Service Bulletin

SUBJECT: Service Update for Inventory and Customer Vehicles
Underhood Electrical Center (UEC) Missing Fuses and Relays
Expires with Base Warranty

MODELS: 2015 Chevrolet Silverado
2015 GMC Sierra
Equipped with Accessory Wiring Junction Block (RPO 9L7)

Subject: 15411 – Service Update Bulletin
Underhood Electrical Center (UEC) Missing Fuses and Relays

4216854

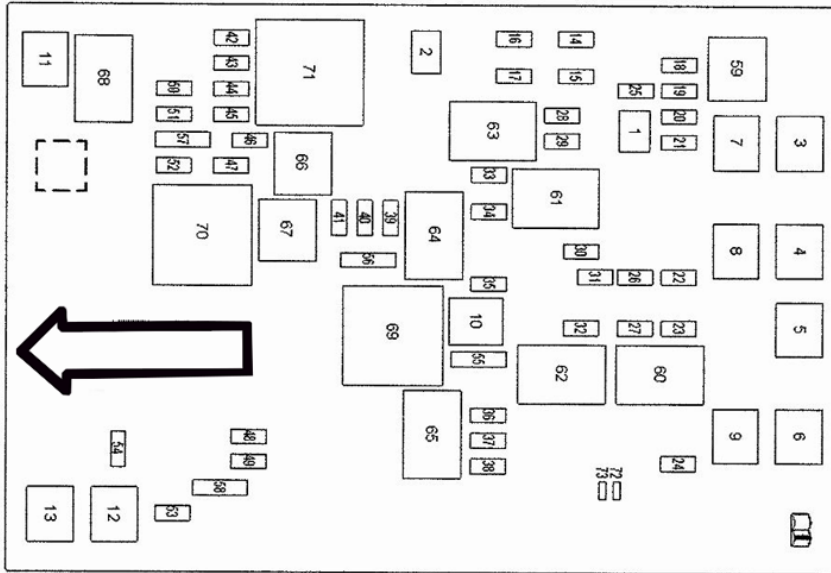
1. Remove the cover from the Underhood Electrical Center (1).

UEC fuse block *before* fuse and relay installation

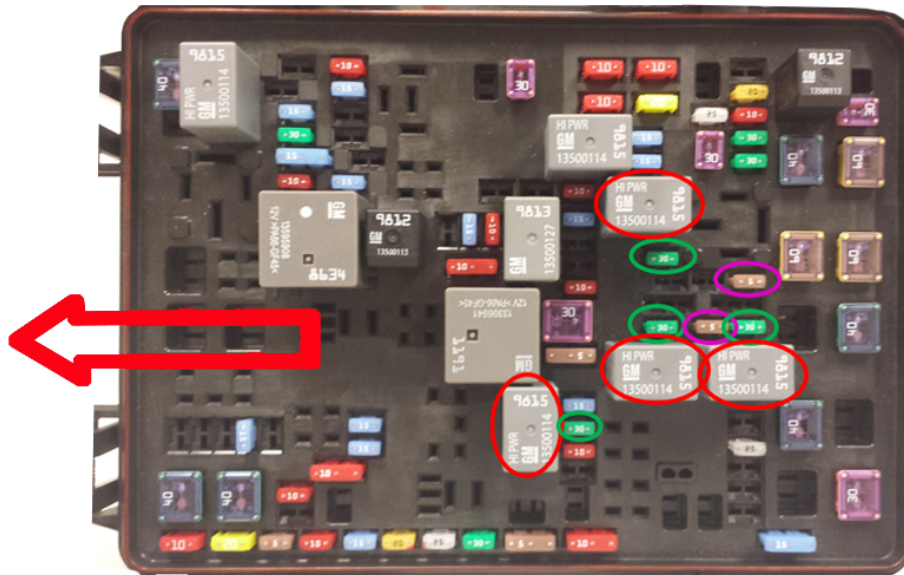
2. Locate fuse positions 22 and 27 circled in purple.
3. Install the **two tan** 5A fuses.
4. Locate fuse positions 23, 30, 32, and 37 circled in green.
5. Install the **four green** 30A fuses.
6. Locate relay positions 60, 61, 62, and 65 circled in red.
7. Install the **four gray** HIPWR relays in their correct orientation.
8. Install the UEC cover, and close the hood.
